Model: G-P2L	Date: 15-Jan-08	No.: RG158001a
--------------	-----------------	----------------

Subject: Firmware Release History (System)		Prepared by: K. Moriizumi	
From: 1st Tech. Support Sec. Service Support Dept.			
Classification:	<input type="checkbox"/> Troubleshooting	<input type="checkbox"/> Part information	<input type="checkbox"/> Action required
	<input type="checkbox"/> Mechanical	<input type="checkbox"/> Electrical	<input type="checkbox"/> Service manual revision
	<input type="checkbox"/> Paper path	<input type="checkbox"/> Transmit/receive	<input type="checkbox"/> Retrofit information
	<input type="checkbox"/> Product Safety	<input checked="" type="checkbox"/> Other ()

Model: General		Date: 12-Mar-08	No.: RGene027
Subject: New Wireless LAN Option		Prepared by: H.K.	
From: 1st Tech. Support Sec. Service Support Dept.			
Classification:	<input type="checkbox"/> Troubleshooting	<input type="checkbox"/> Part information	<input checked="" type="checkbox"/> Action required
	<input type="checkbox"/> Mechanical	<input type="checkbox"/> Electrical	<input checked="" type="checkbox"/> Service manual revision
	<input type="checkbox"/> Paper path	<input type="checkbox"/> Transmi

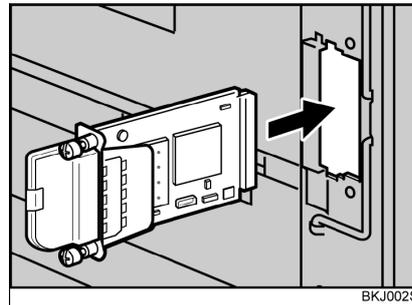
Previous types:
PCB, LAN card, and cover are separate

New Type (IEEE802.11b Interface Unit Type N):
Pre-assembled
